**SPRINGFIELD TOWNSHIP PLANNING COMMISSION**

**Tuesday, December 5, 2023**

Reference: 902 E. Pleasant Avenue – Subdivision Application

Reference: 1301 E. Mermaid Lane – Land Development Application

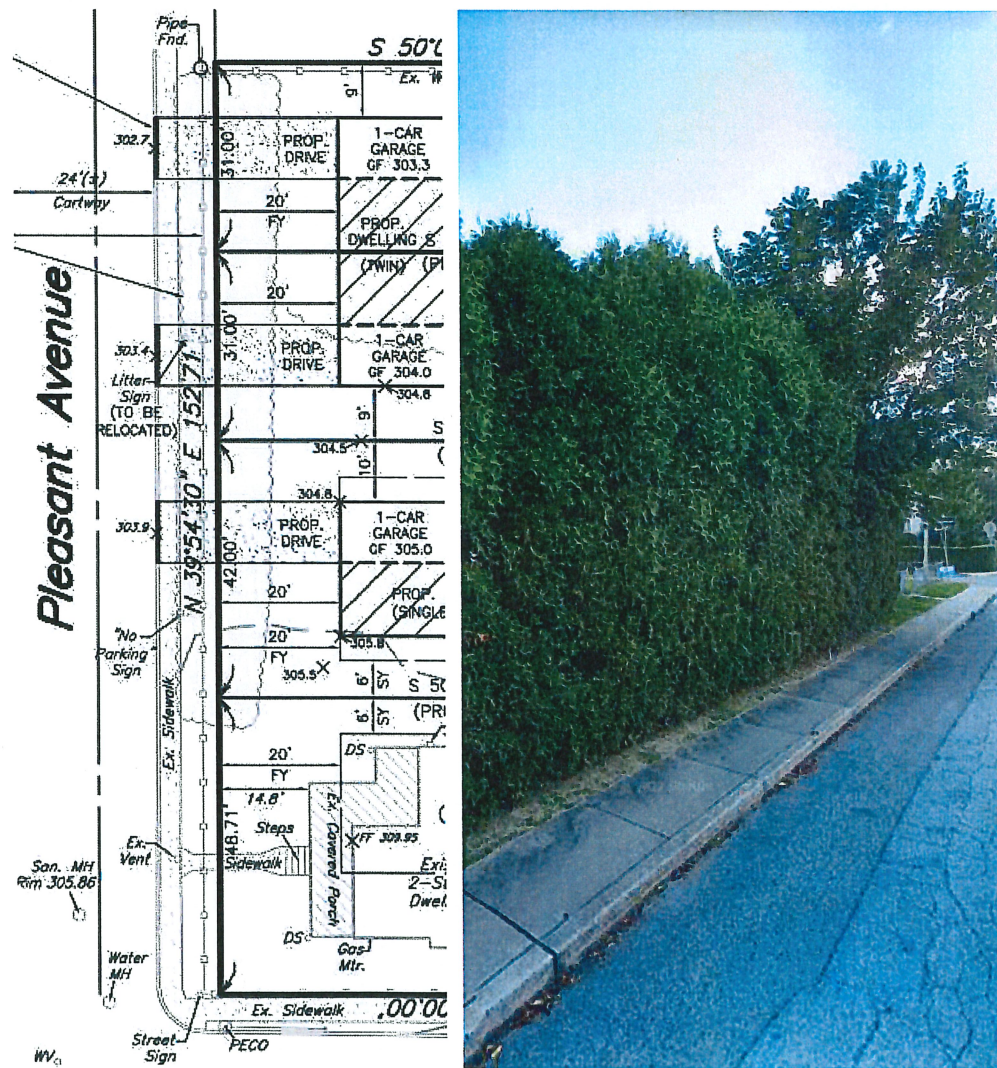
- A. Seepage Beds. It is unclear from the plan submitted to us whether the seepage bed shown on the plan for lots 2-4 is intended to be a singular seepage bed for all three parcels or one seepage bed for each of the proposed parcels.

1. If the seepage bed shown is intended to be a singular seepage bed for all three parcels, the applicant is advised to ensure that an agreement is in place regarding payment of seepage bed maintenance and inspection costs.

2. If the seepage bed shown is intended to be a separate seepage bed for each of the proposed parcels, then it appears that the seepage beds for lots #2 and #3 are lacking an overflow pipe, and the applicant may wish to clarify what would happen if the seepage beds for lot #2 and lot #3 overflow.

SITE GRADING PLAN OF 1301 MERMAID LANE PREPARED FOR ROBERTSON & FERRY, LP 1301 MERMAID LANE WYNDMOOR, PA 19038

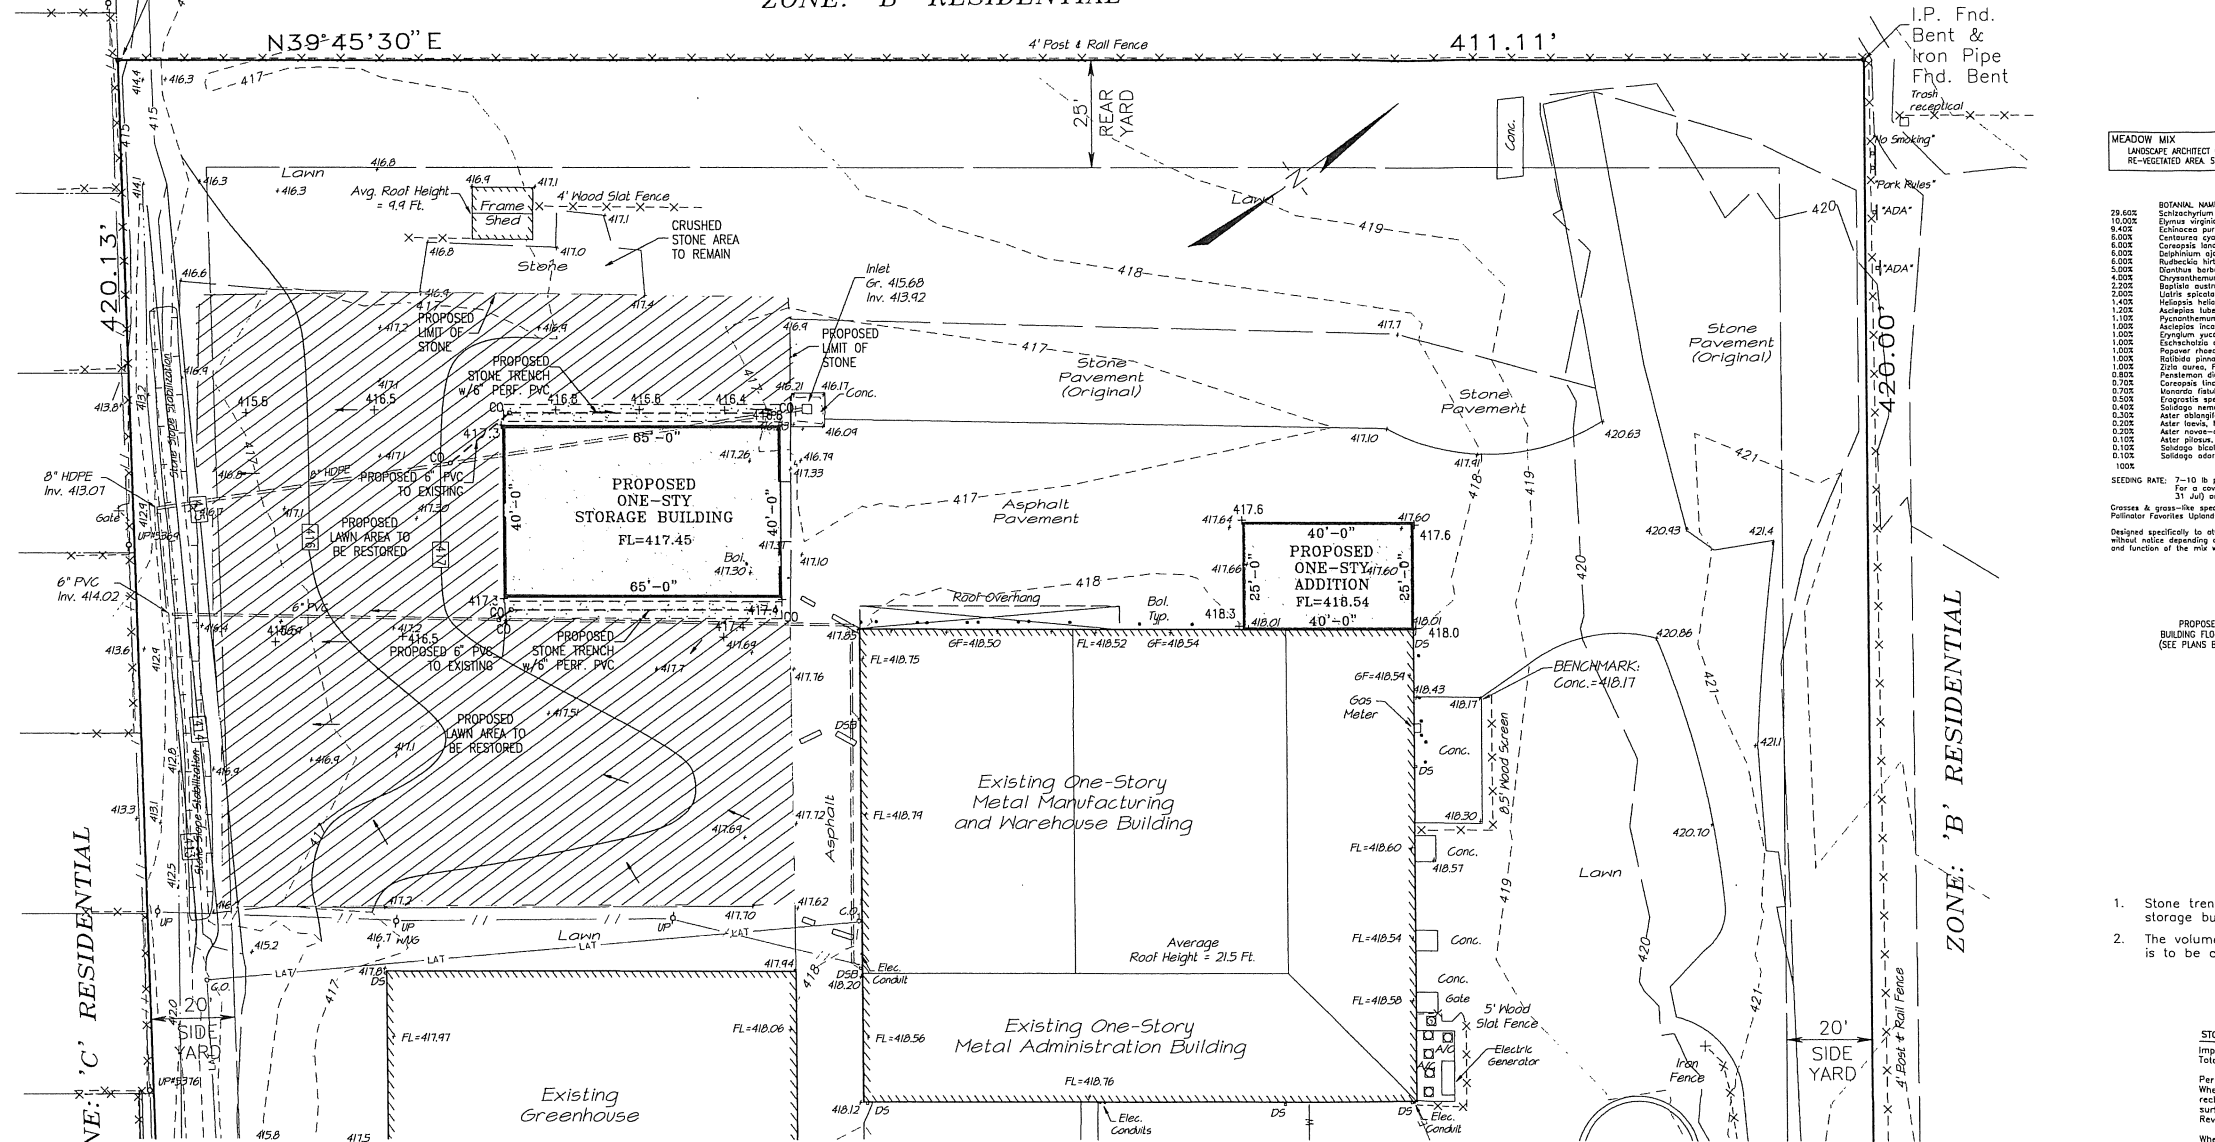
2. Section 95-4 – It is my recommendation that the Record Plan as well as Sheet 2 of 6 be recorded with the Montgomery County Recorder of Deeds office in conjunction with this application. The recording of the plan will memorialize expectations set by the Township, giving us a yardstick to measure compliance as well as future improvement requests.

1. **Swale** – While the proposed contour lines show the removal of fill material that was recently placed within the southern property line swale, it would be appropriate for a clear plan note to be placed, giving the contractor clear direction as to his obligation to restore the cross-section of the channel and the removal of all fill material to the satisfaction of the Township staff.
